SUBMITTAL SUMMARY REPORT (MasterPlan-000805-2026)

PLAN NAME:	Heatherwood PUD	**LOCATION:**	8490 JUNIPER RD OCALA,
APPLICATION DATE:	05/21/2026	**PARCEL:**	36640-004-00
DESCRIPTION:	Heatherwood PUD

Heatherwood Master Plan
MasterPlan-000805-2026

HEATHERWOOD
PUD MASTER PLAN

SHT. 01.01

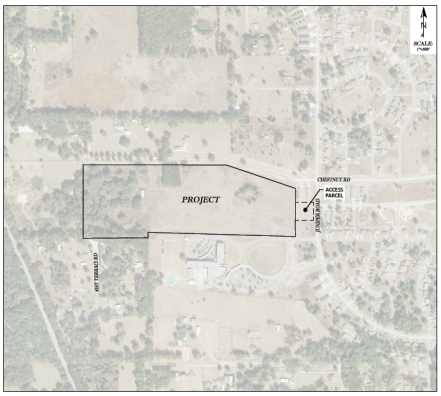
Corrections Project Boundary (**Resolved**) - **Corrective Action:** When reviewing the Preliminary Plat and Improvement Plan, this plan appears to include parcel 9025+0644-03. On Sheet 01.01 please make necessary corrections to reflect the most accurate information and please update the Project Boundary lines on all applicable sheets on future submittals. - Project Boundary: 2.12.8 - Project boundary clearly defined

Corrections Project Boundary (**Not Resolved**) - **Corrective Action:** When reviewing the Preliminary Plat and Improvement Plan, this plan appears to include parcel 9025+0644-03. On Sheet 01.01 please make necessary corrections to reflect the most accurate information and please update the Project Boundary lines on all applicable sheets on future submittals. - Project Boundary: 2.12.8 - Project boundary clearly defined

Corrections Additional Growth Services comments (**Not Resolved**) - **Corrective Action:** Parcel numbers for parcels being used for access need to be included on the cover page as noted by Jamie Waldron on the cover page. - Parcel numbers for parcels being used for access need to be included on the cover page as noted by Jamie Waldron on the cover page.

REVIEWER	MARKUP	DATE/TIME	FILE NAME	PG #
Jamie.Waldron	The Preliminary Plat and Improvement Plan include Parcel 9025+0644-03. Please make necessary corrections to reflect the most accurate information. Please update Project Boundary lines on all applicable sheets on future submittals.	06/16/2026 9:08	PM_Combined Plans.pdf	1

s:\marion county\dr horton- juniper loop flix chestnut hill pud\PLANNING\master plan\06.01 MASTER PLAN.dwg, 5/5/2026 3:11:14 PM, AutoCAD PDF (General Documentation).pc3

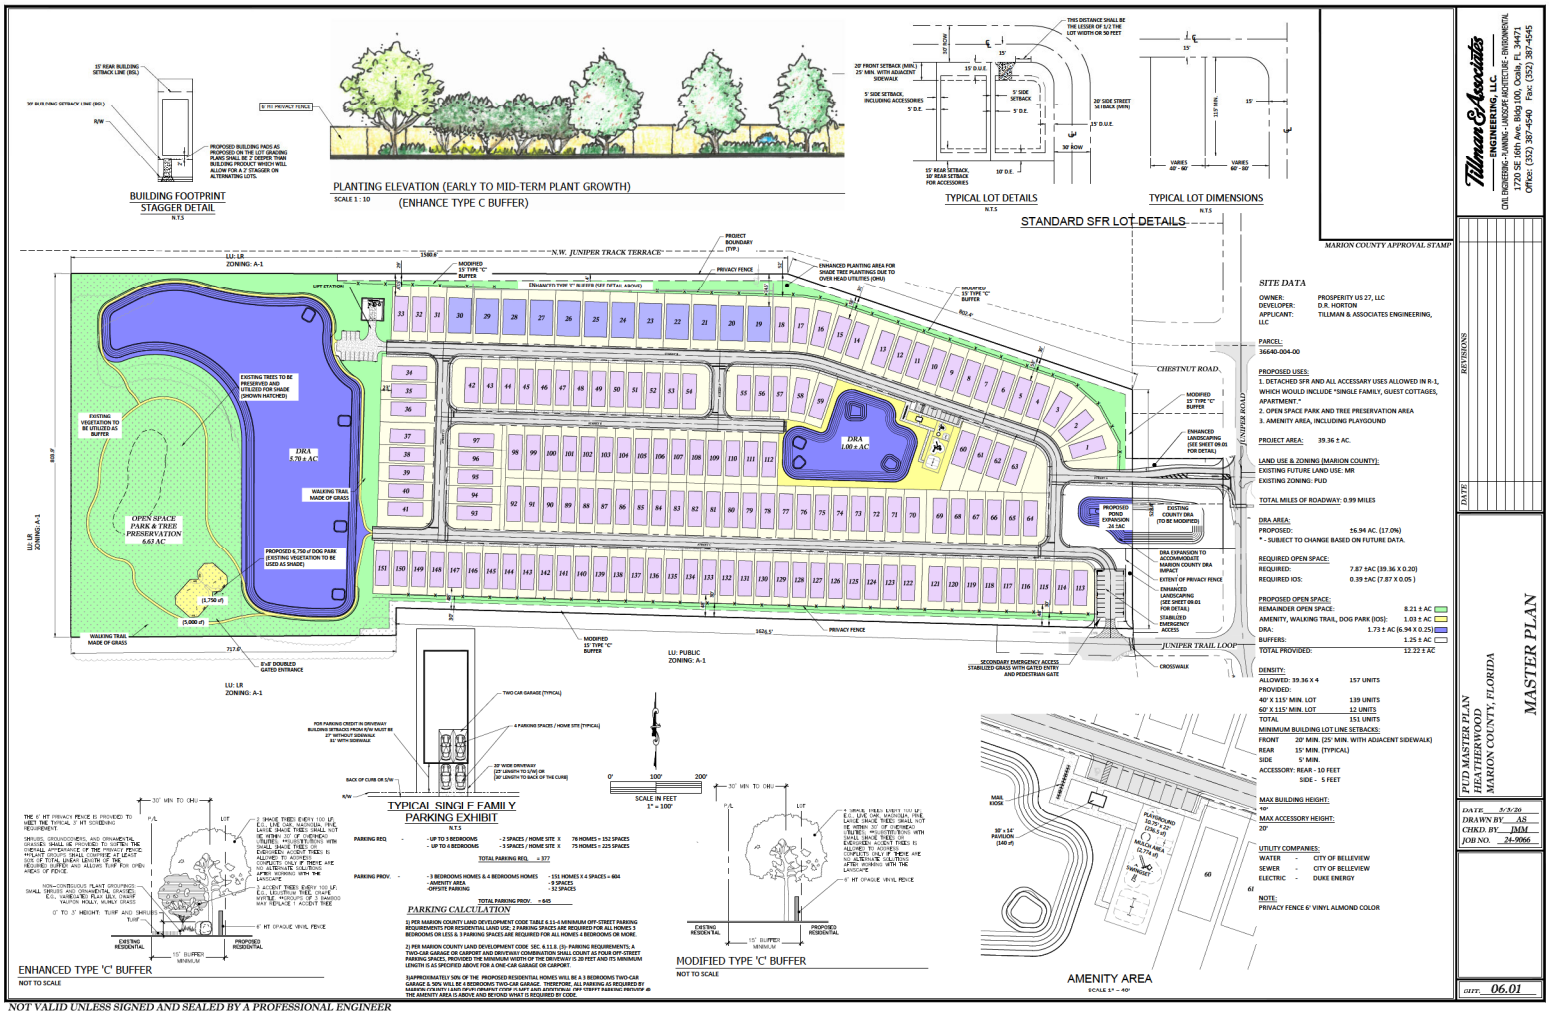
Corrections Existing Roads Labeled Correctly (**Resolved**) - **Corrective Action:** Sheet 06.01 needs the label for Chestnut Road removed as the portion west of Juniper Road is a driveway/easement, not a named road. - Existing Roads Labeled Correctly: 2.12.28 - Existing roads marked with official 9-1-1 road names

Corrections Existing and Proposed Roads Shown (**Resolved**) - **Corrective Action:** The new roads have been labeled on Sheet 06.01. Be sure they are labeled on all future submittals. - New Road Name Labels

Corrections Existing Roads Labeled Correctly (**Resolved**) - **Corrective Action:** Sheet 06.01 needs the label for Chestnut Road removed as the portion west of Juniper Road is a driveway/easement, not a named road. - Existing Roads Labeled Correctly: 2.12.28 - Existing roads marked with official 9-1-1 road names

Corrections Existing Roads Labeled Correctly (**Not Resolved**) - **Corrective Action:** Sheet 06.01 needs the label for Chestnut Road removed as the portion west of Juniper Road is a driveway/easement, not a named road. - Existing Roads Labeled Correctly: 2.12.28 - Existing roads marked with official 9-1-1 road names

Corrections Existing and Proposed Roads Shown (**Not Resolved**) - **Corrective Action:** The new roads have been labeled on Sheet 06.01. Be sure they are labeled on all future submittals. - New Road Name Labels

REVIEWER	MARKUP	DATE/TIME	FILE NAME	PG #
Alexander	Please label the easements	05/22/2026 1:22	PM_Combined Plans.pdf	8
Janet W	JUNIPER PASS	05/27/2026 9:51	AM_Combined Plans.pdf	7
Janet W	JUNIPER TRAIL DR	05/27/2026 9:51	AM_Combined Plans.pdf	7
Janet W	JUNIPER TRAIL DR	05/27/2026 9:52	AM_Combined Plans.pdf	7
Janet W	JUNIPER TRAIL DR	05/27/2026 9:52	AM_Combined Plans.pdf	7
Janet W	JUNIPER TRAIL CT	05/27/2026 9:52	AM_Combined Plans.pdf	7
Janet W	JUNIPER TRAIL TRCE	05/27/2026 9:52	AM_Combined Plans.pdf	7
Janet W	JUNIPERTRAILRADL	05/27/2026 9:53	AM_Combined Plans.pdf	7
Janet W	JUNIPER TRAIL WAY	05/27/2026 9:53	AM_Combined Plans.pdf	7
Janet W	JUNIPER TRAIL WAY	05/27/2026 9:53	AM_Combined Plans.pdf	7
Janet W	JUNIPERTRAIL WAY	05/27/2026 9:53	AM_Combined Plans.pdf	7
Janet W	Added new road names to this sheet.	05/27/2026 9:54	AM_Combined Plans.pdf	7
Janet W	Remove road name label. This is an easement, not a named road.	05/27/2026 10:23	AM_Combined Plans.pdf	7

CIRCULATION PLAN

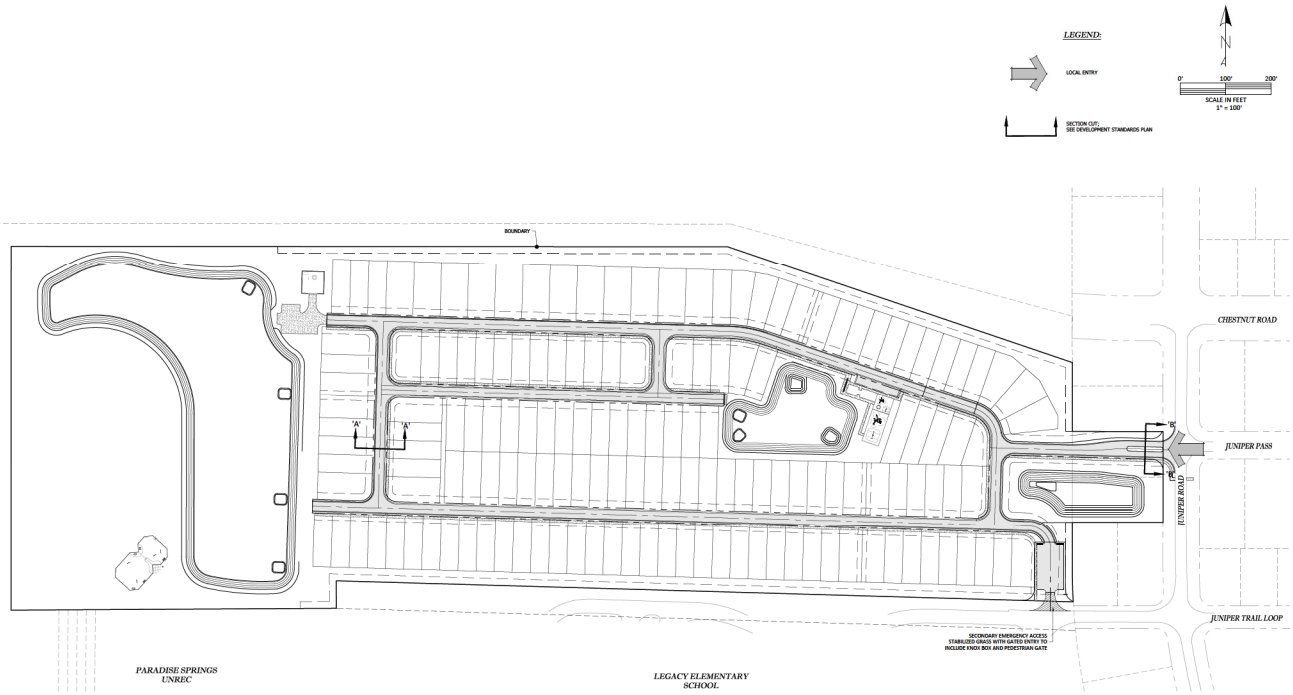
Corrections 6.12.9 - Subdivision roads (**Not Resolved**) - **Corrective Action:** Please show the hammerheads on the dead ends as required in the approved waiver. - 6.12.9 - Subdivision roads : Subdivision roads must meet the design requirements in Section 6.12.9.

Corrections 6.12.9 - Subdivision roads (**Resolved**) - **Corrective Action:** All dead end streets are required to end in a cul-de-sac. Staff supports a waiver for streets that are 150 feet or less subject to providing a paved hammerhead turnaround. - 6.12.9 - Subdivision roads : Subdivision roads must meet the design requirements in Section 6.12.9.

Corrections 6.12.9 - Subdivision roads (**Not Resolved**) - **Corrective Action:** All dead end streets are required to end in a cul-de-sac. Staff supports a waiver for streets that are 150 feet or less subject to providing a paved hammerhead turnaround. - 6.12.9 - Subdivision roads : Subdivision roads must meet the design requirements in Section 6.12.9.

LDC 6.12.8 - SURDIVISION ROADS AND RELATED INFRASTRUCTURE
A WAIVER TO ALLOW FOR THE PROPOSED DESIGN AND POSTED SPEED. CURVE WARNING SIGNAGE PER FDOT GREENBOOK CRITERIA IS PROPOSED AS SHOWN ON SHEET 07.01 . (CASE 000646-2026 APPROVED JUNE 08, 2026)

6.12.5 (E) - SUBDIVISION ROADS AND RELATED INFRASTRUCTURE
A WAIVER TO ALLOW FOR THE USE OF A HAMMERHEAD STYLE INTERSECTION ON DEAD END ROADS. THE PROPOSED DEAD END SEGMENTS WILL BE LESS THAN 150' IN LENGTH. (CASE 000646-2026 APPROVED JUNE 08, 2026)
